UNITED STATES PATENT AND TRADEMARK OFFICE

APPLICATION NO.	FILING DATE	FIRST NAMED INVENTOR	ATTORNEY DOCKET NO.	CONFIRMATION NO.
10/772,944	02/05/2004	John E. Kast	151P08970US02	5311

Office Action Summary	Application No. 10/772,944	Applicant(s) KAST ET AL.	
	Examiner Erik J. Bustamante	Art Unit 3766

DETAILED ACTION

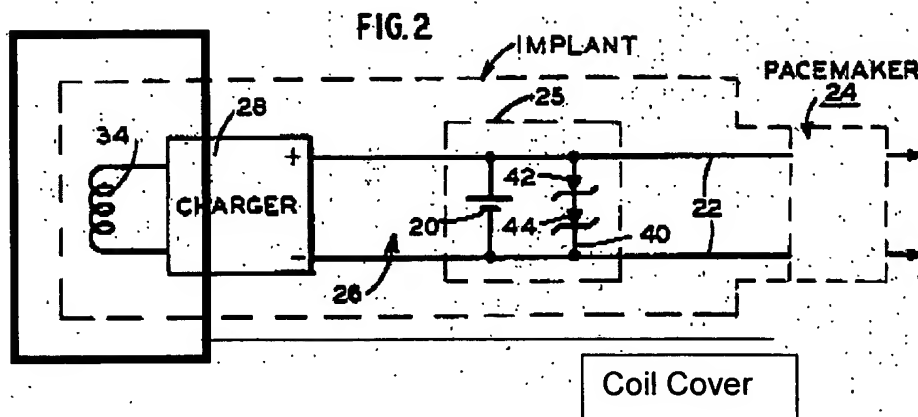
Regarding claim 5, FAGAN Jr. discloses a coil cover (see Figure below), which inherently is attached to the housing. The examiner interprets the area covering

the coil (34) to function as the coil cover and the area covering the rest of the electronics to be the housing.

Regarding claim 9, FAGAN Jr. discloses a coil alignment carrier (28), which carries the coil, the coil alignment carrier positioned between the coil cover and the housing (see the Figure above).
